**Use of the Manual of Tests and Criteria in the context of  
GHS**

**Transmitted by the Chairman of the Working Group on Explosives of  
the Sub-Committee of Experts on the Transport of Dangerous Goods  
(TDG Sub-Committee) on behalf of the Working Group**

1. Document ST/SG/AC.10/C.3/2018/62–ST/SG/AC.10/C.4/2018/16 contains the list of amendments to Part III of the Manual of Tests and Criteria, agreed by the Working Group on Explosives and recommended for adoption by the TDG and GHS sub-committees.
2. This document contains the text of part III sections 30 to 37 as well as subsections 38.1 and 38.2 of the sixth revised edition of the Manual of Tests and Criteria, as amended by ST/SG/AC.10/C.3/2018/62–ST/SG/AC.10/C.4/2018/16. All the proposed amendments are indicated: inserted text is shown in blue (**inserted**); deleted text is shown in red, strikethrough (~~deleted~~).

## “PART III

**FIGURE 31.1: OVERALL PROCEDURE FOR CLASSIFICATION OF FLAMMABLE AEROSOLS**

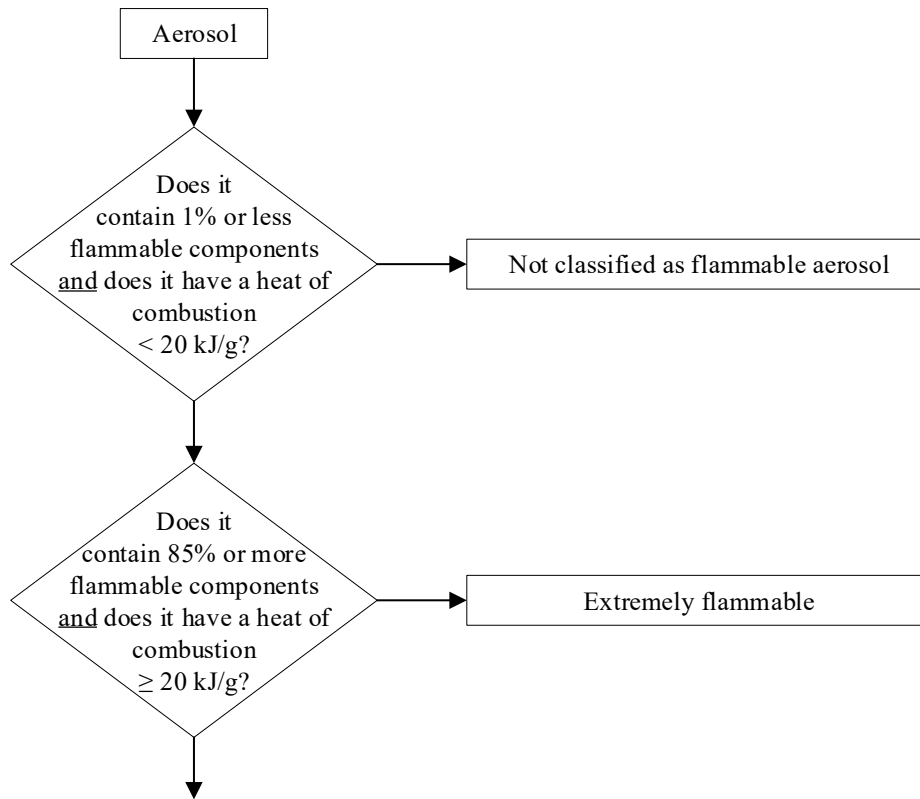
31.3.5 The classification **criteria procedure** for aerosols, spray aerosols and foam aerosols is summarized in figures 31.1, 31.2 and 31.3 respectively.

Figure 33.2-1.3 : FLOW CHART FOR THE CLASSIFICATION OF FLAMMABLE ~~ASSIGNING READILY COMBUSTIBLE~~ SOLIDS, EXCEPT METAL POWDERS, ~~TO DIVISION 4.1~~

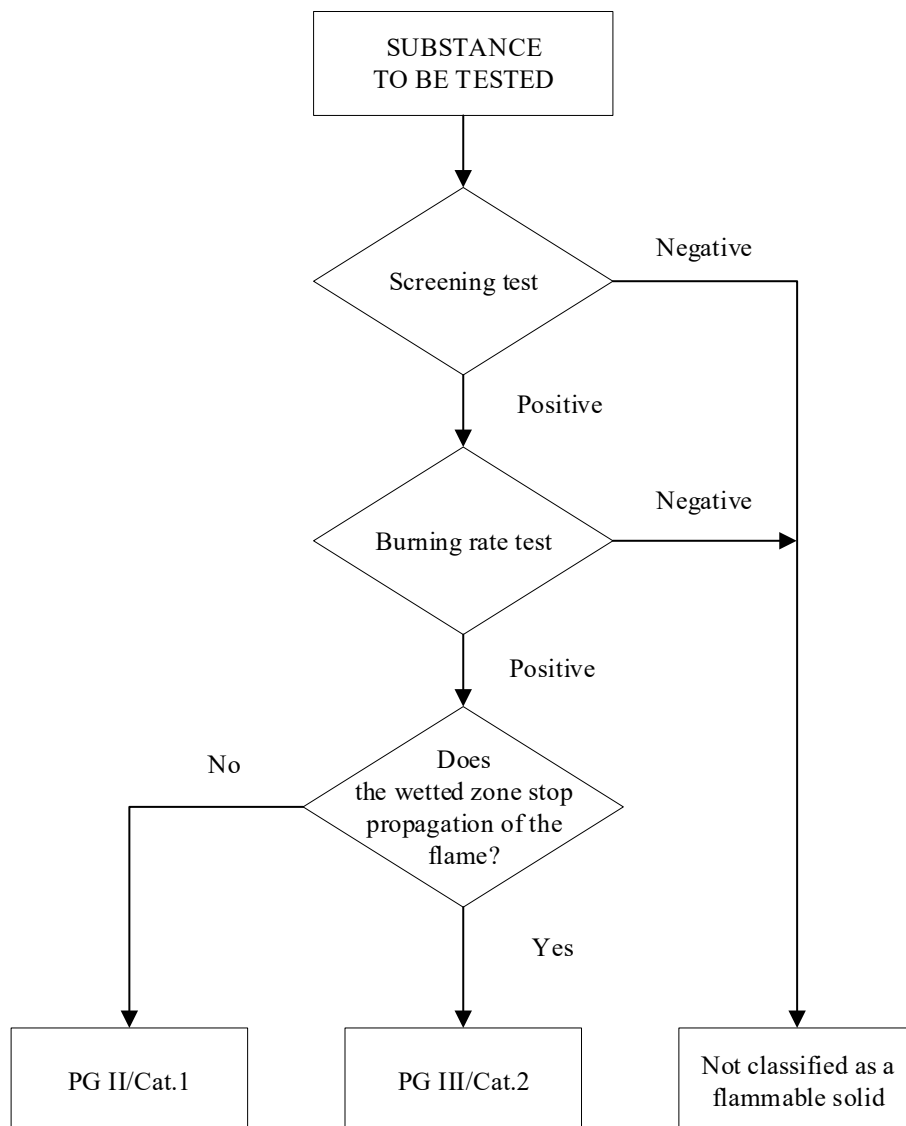
~~33.2.1.1.1~~ Section ~~33.2.1.3~~ presents the United Nations scheme for the classification of readily combustible solids ~~of Division 4.1~~ (see sub-section 2.4.2.2 of the Model Regulations and Chapter 2.7 of the GHS). The text should be used in conjunction with the classification principles given in paragraphs 2.4.2.2.2 and 2.4.2.2.3 of the Model Regulations, paragraph 2.7.2 of the GHS, the flow chart given in Figure ~~33.2.1.3~~ and the test prescription given ~~here~~ in ~~33.2.1.4~~.

Figure 33.3-1.4.3.3.1: CLASSIFICATION OF SELF-HEATING SUBSTANCES

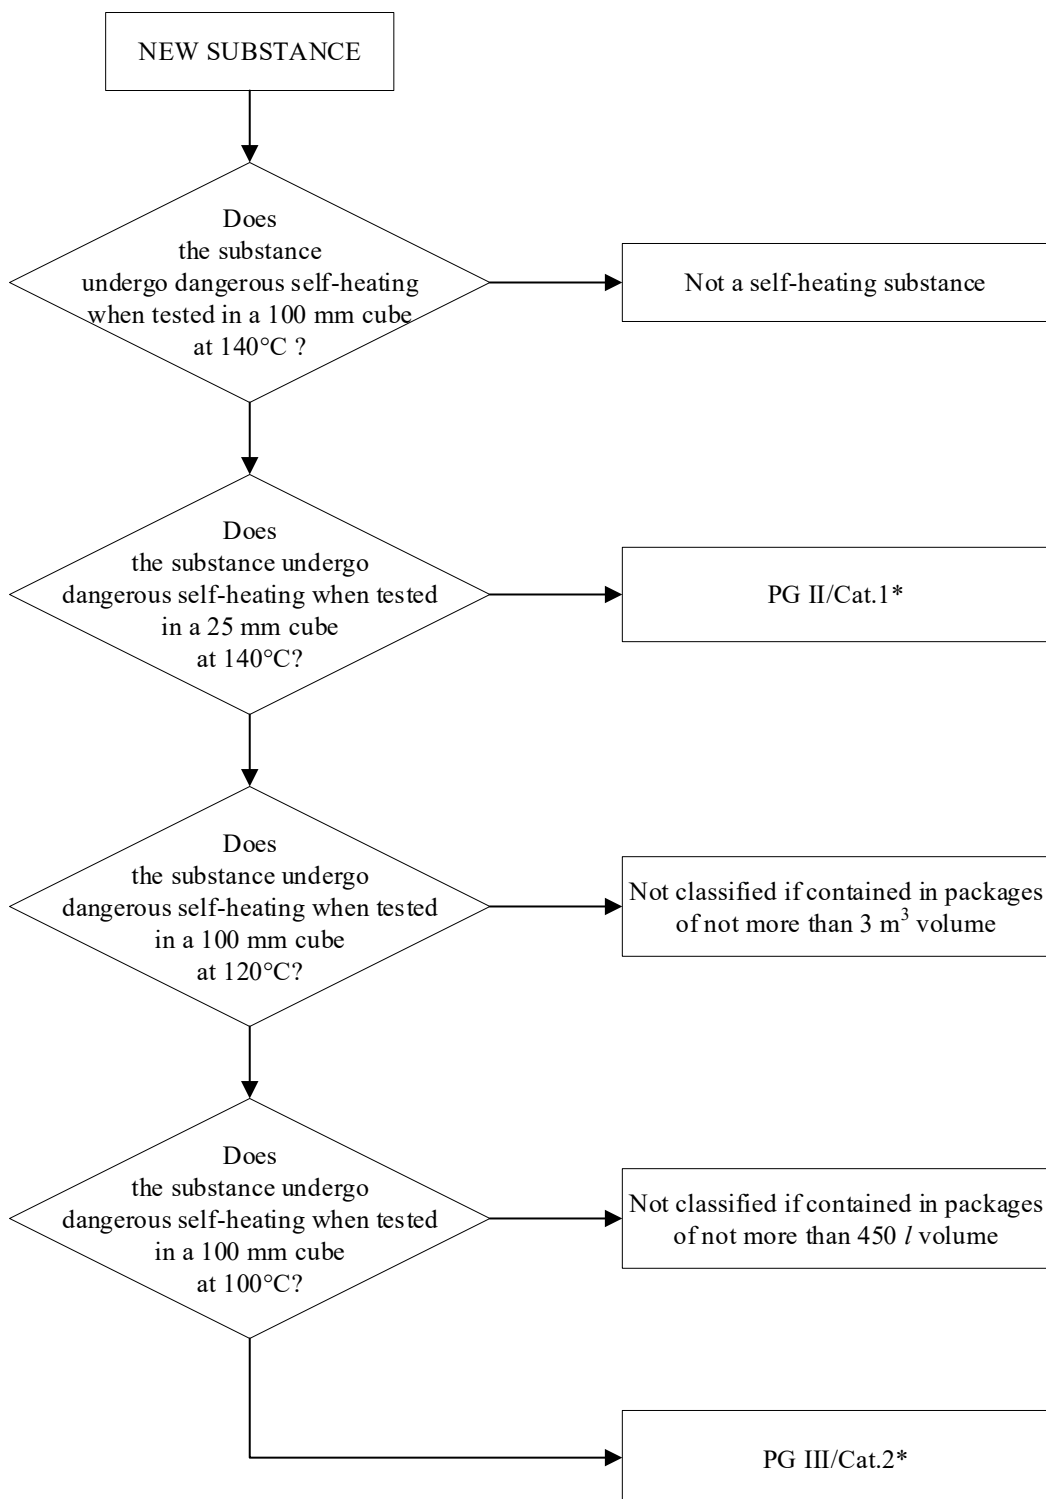
~~33.3.1.4.3.3.1~~      Tests are performed to determine if substances in a 25 mm or 100 mm sample cube, at test temperatures of 100 °C, 120 °C or 140 °C, undergo spontaneous ignition or dangerous self-heating, which is indicated by a 60 °C rise in temperature over the oven temperature within 24 hours. The classification scheme is illustrated in Figure ~~33.3.1.4.3.3.1~~. These criteria are based on the self-ignition temperature of charcoal, which is 50 °C for a sample cube of 27 m<sup>3</sup>. Substances with a temperature of spontaneous combustion higher than 50 °C for a volume of 27 m<sup>3</sup> should not be ~~classified as a self-heating substance assigned to Division 4.2~~. Substances with a spontaneous ignition temperature higher than 50 °C for a volume of 450 litres should not be assigned to packing group II / ~~Category 1 of Division 4.2~~. The recommended test method is given ~~here~~ in ~~33.3.1.4.6~~.
